Tuerk House - Phase-4 RM Sovich Architecture

Item #	RFI#	Name	Date received	Generated by	Dwg / Spec #	Description/question	Conflicting Sheet/ Spec #	Date/ Forwarded to	Date/ Received from	Arch/Engineer Response Date	Arch/ Engineer Response Date	Arch / Engineer Response	Revised drawings/Spec.	Responsibility	Status	ADDENDUM #
1	1	Kim	8/25/23	TBI		Please provide more details on the steps from the penthouse to the roof.						Stair is a non penetrating stair system. Attachment detail if required will be provided once shop drawings are submitted. Refer to specification sheet on section 055000 - non penetrating roof top stair system.		Architect	New Item	ADD#01
2	1	Kim	8/25/23	TBI		2. There is no roof spec. Please provide more detail regarding both roofs.						For the shade roof refer to specification on section 074000. For the canopy roof see the attached spec section 07 53 23 ADHERED EPDM ROOF.		Architect	New Item	ADD#01
3	1	Kim	8/25/23	TBI		3. There are metal guardrails @ Ashburton St main entrance det D6/A2.01, and at stepped seating det B6/A2.5. both are called to be painted. However, ASI-07/5.A calls for stainless steel. Please advise if any railing needs to be field painted.						P

POWER PLAN-PH-4

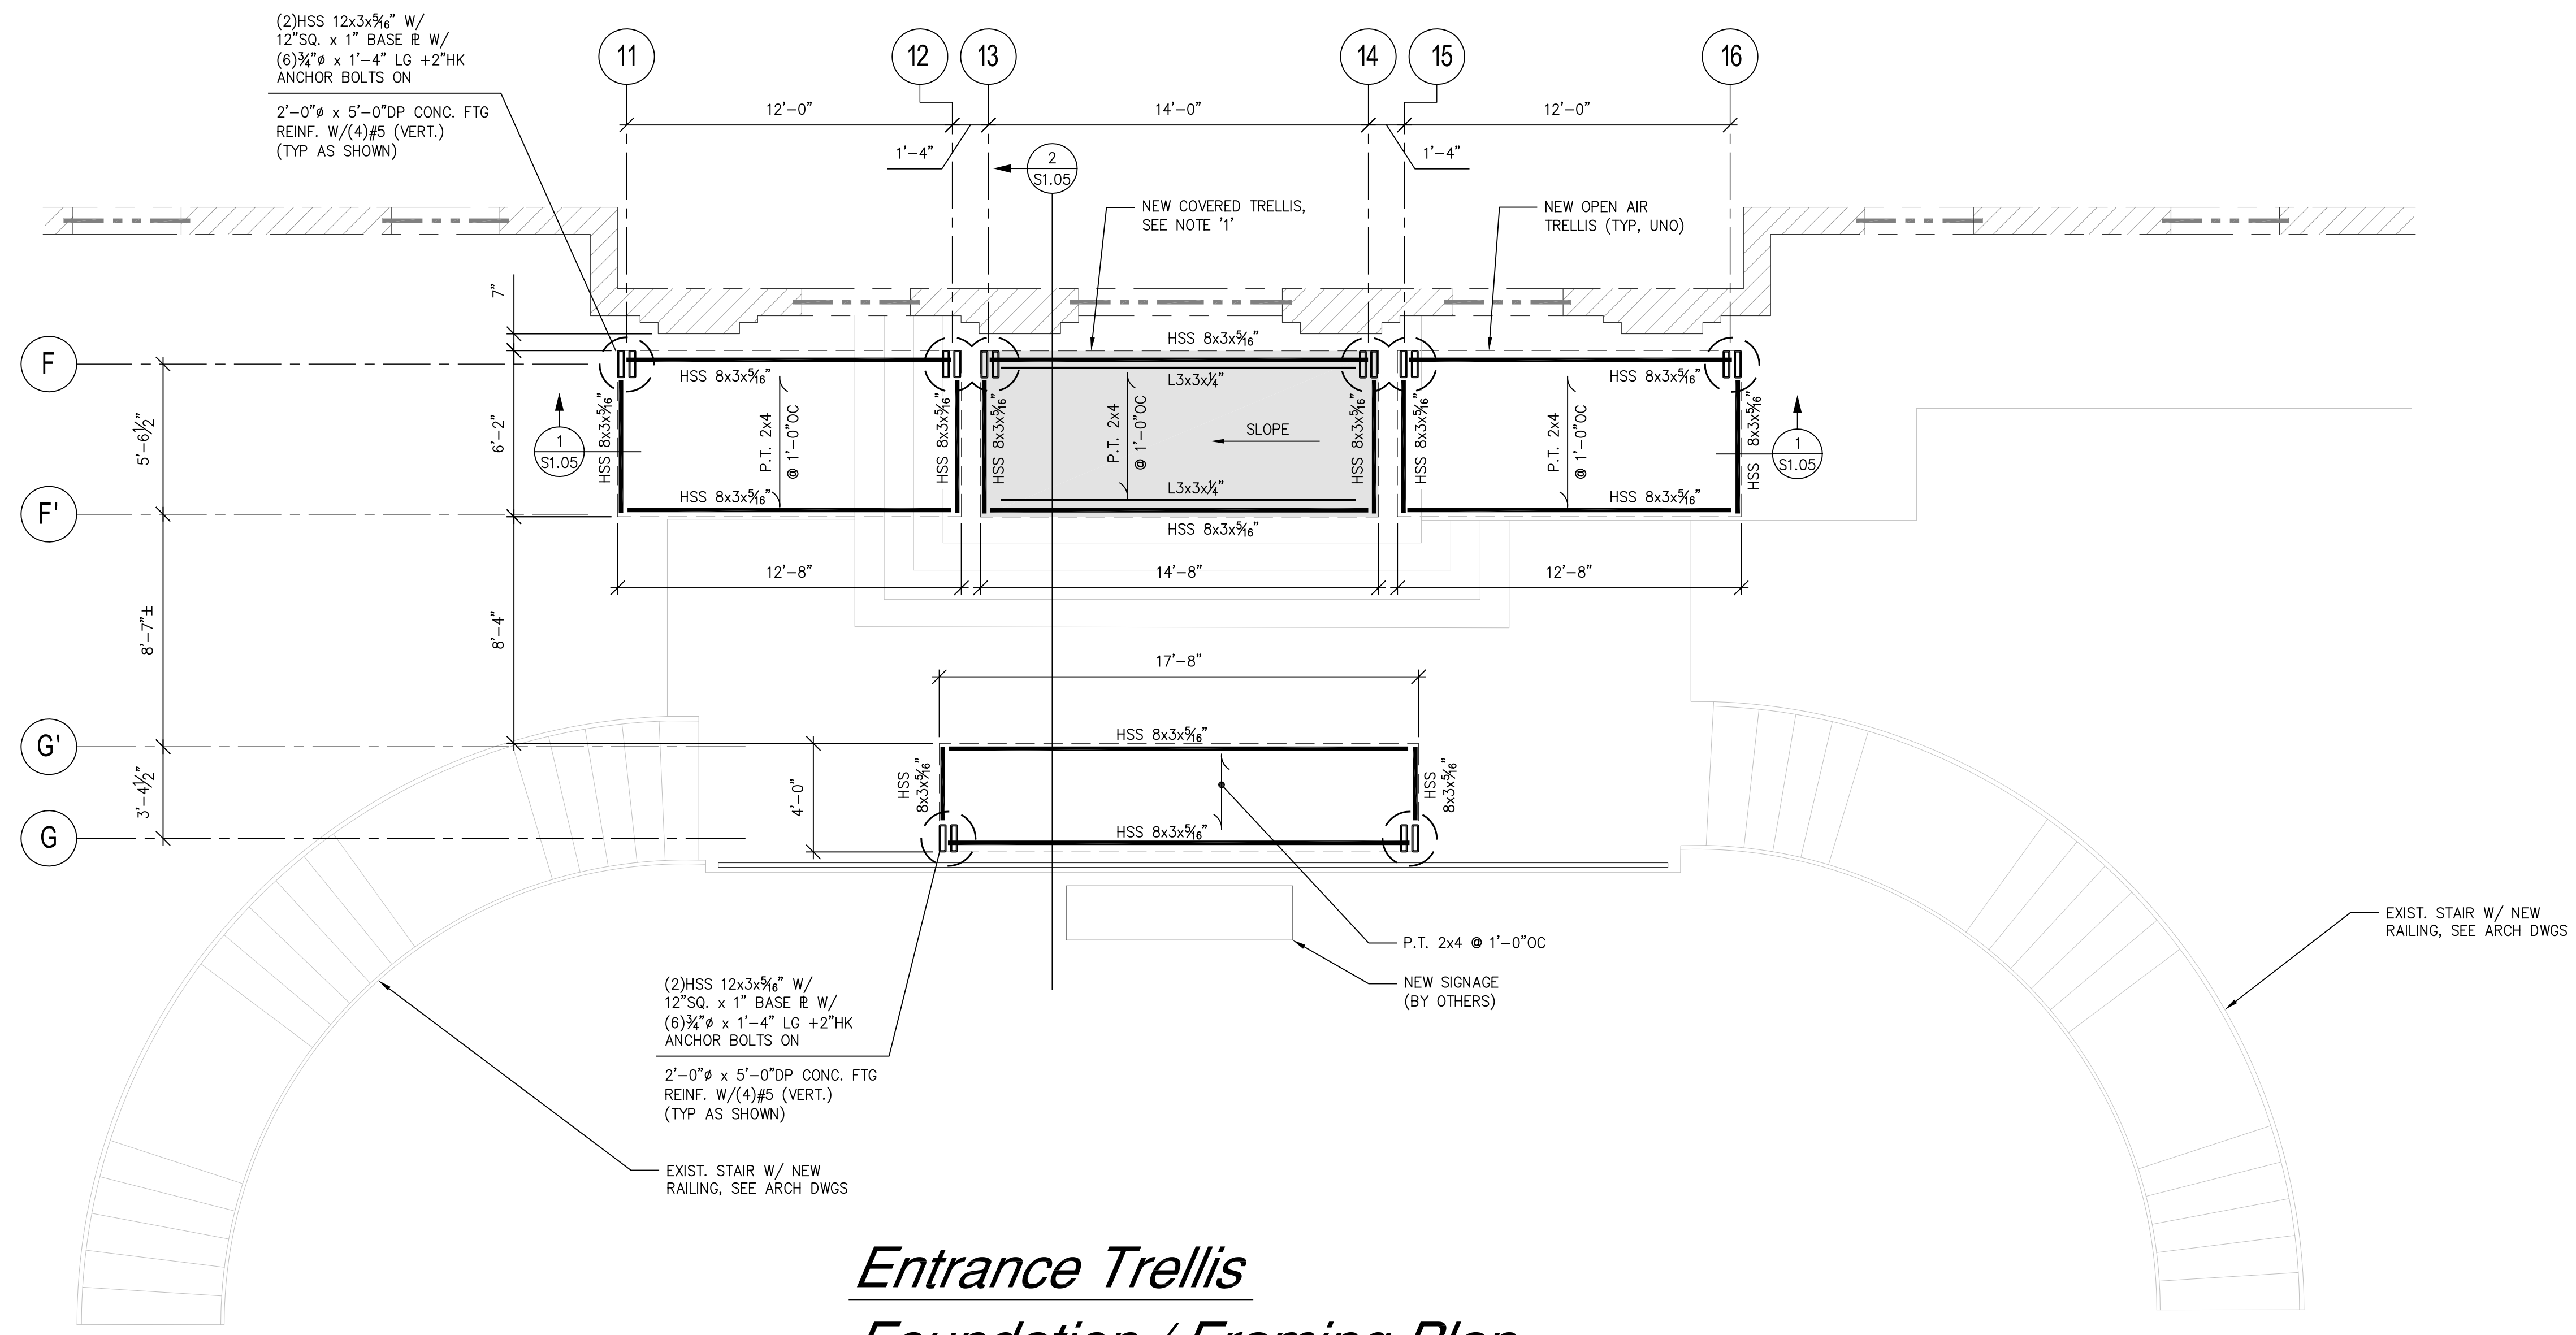
8	1	Kim	8/25/23	TBI		8. Does the crawl space need to be sprinkled?						No need to sprinkler the crawl space.		Architect	New Item	ADD#01
9	1	Kim	8/25/23	TBI		9. There are no materials specified for exterior steel. Please provide a spec.		8/25/23 SKA				See the steel structural specification on S0.01	S0.01	Structural	New Item	ADD#01
10	1	Kim	8/25/23	TBI		10. Feeder to shed: On drawing E5.0, it shows a new feeder from panel DP to shed panel S-1A, On drawing E4.2, it shows the location of panel S-1A and DP panel. These are shown in two details. There is no reference to show where the utility room 117B is in relation to the shed. I need to know the distance to the shed. Will this feeder be installed underground? What is the route?		8/25/23 Ceca				Feeder shall be installed underground per code. We have shown Room 117 on Telephone and electric location plan.		MEP	New Item	ADD#01
11	1	Kim	8/25/23	TBI		11. Planter Junction box. On drawing E4.1 it shows junction boxes in the planters. Only one of the planters has a receptacle (GFI). Confirm that there aren't any additional receptacles needed for the planters.		8/25/23 Ceca				Only one receptacle as It is shown on E4.2.		MEP	New Item	ADD#01
